River Hamble Harbour Authority

Warsash Slipway

Report R.2115

May 2013

**Warsash Slipway Proposal
 (Plan View)**

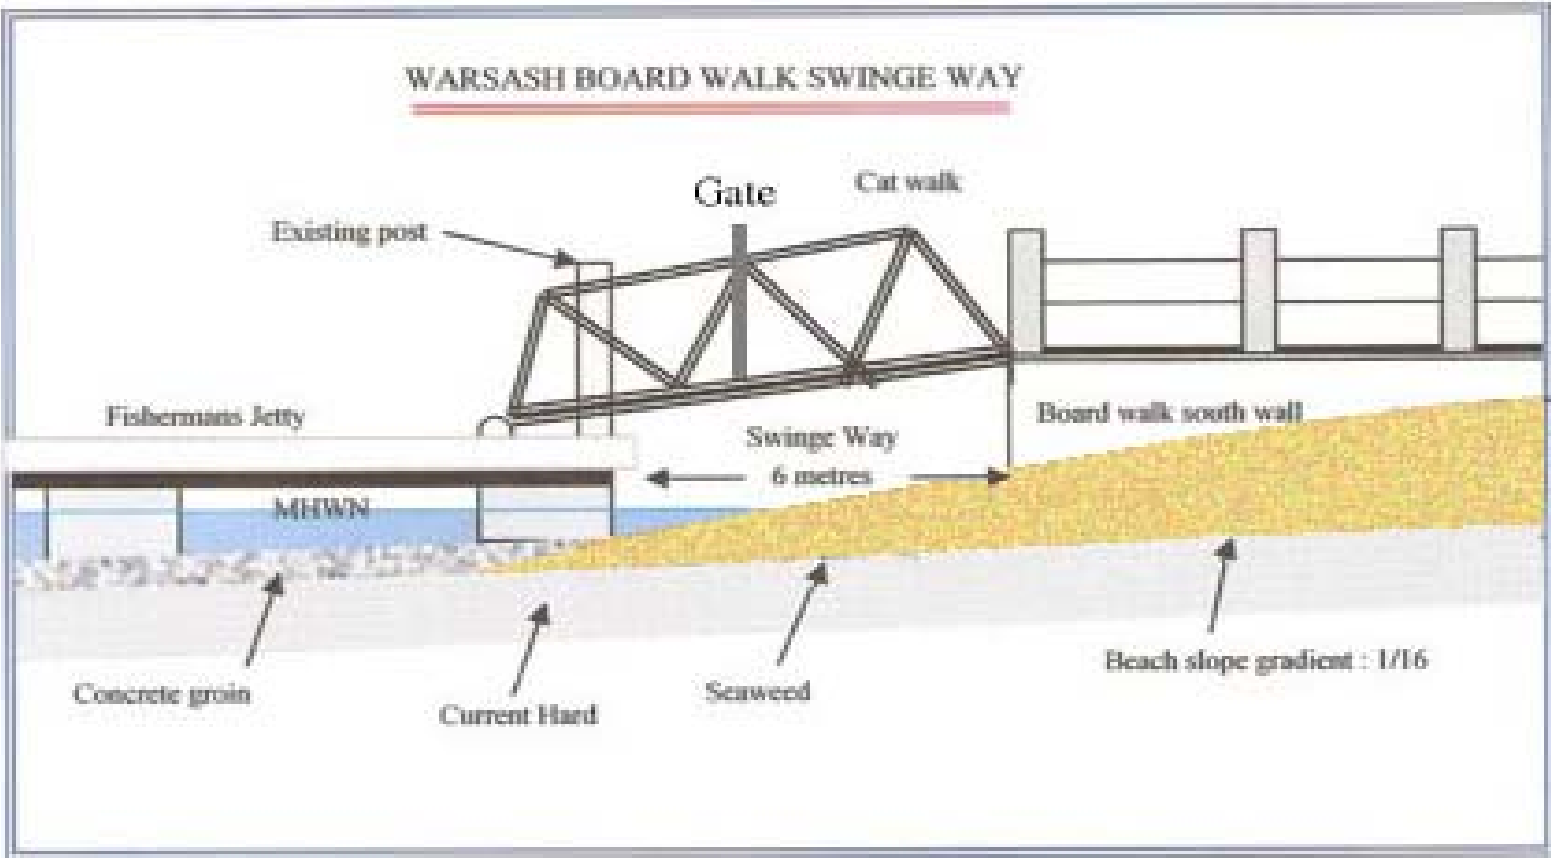
There are concerns that any form of placed shingle will not be suitable for trafficking with vehicle's and trailers. The likelihood will be that the vehicles will get stuck in the 'loose' material, sinking into ruts formed in the running surface. If a firm running surface for the slipway is the desired option then it is considered that the proposed option is unlikely to perform adequately.

The infill material should be reinforced using a base layer of geomembrane and then geogrids inserted into the granular matrix to help control any settlement which may be expected both from vehicular transport across the fill, and compression of the softer bearing strata of the foreshore. The stratigraphy of foreshore should be investigated so that this measure can be assessed. The same granular material used for filling the upper beach can be used (Client Item 4).

The length of the proposed board structure will be sufficient for the desired improvement of the slipway in this area and it is recommended that marker posts are included as part of this item of the works in order to aid navigation. The design proposed for this item at this preliminary stage consists of:

The proposed plan as shown in Figure 2 does not indicate the existing difference in level between the location of the gravel retaining board and the existing slipway as shown in Figure 1. If re-grading (levelling across the width) of the lower slipway is not required then the 100mm protrusion of the gravel retaining board to hold the 'Grasscrete' and new surface gravel will have no significant physical effect. The inclusion of marker posts will benefit the users of the slipway.

It is almost impossible to create a slipway that will remain clear of shingle and seaweed with a gravel makeup. To achieve the required result it would be necessary to firstly raise the level of the slipway at the head above the adjacent beach to keep off any shingle that moves into the area, and secondly form it in such a way so as to provide a firm running surface. This could be achieved by laying something similar to Grasscrete, i.e. a concrete mattress block system that

- A/ 50mm x 100mm x 5500mm timber retaining boards of suitable hardwood species;
- B/ 75mm x 75mm x 450mm timber posts of suitable hardwood species at 1000mm centres; and
- C/ Granular fill to upstream side of the gravel retaining board with fall of 1:15.
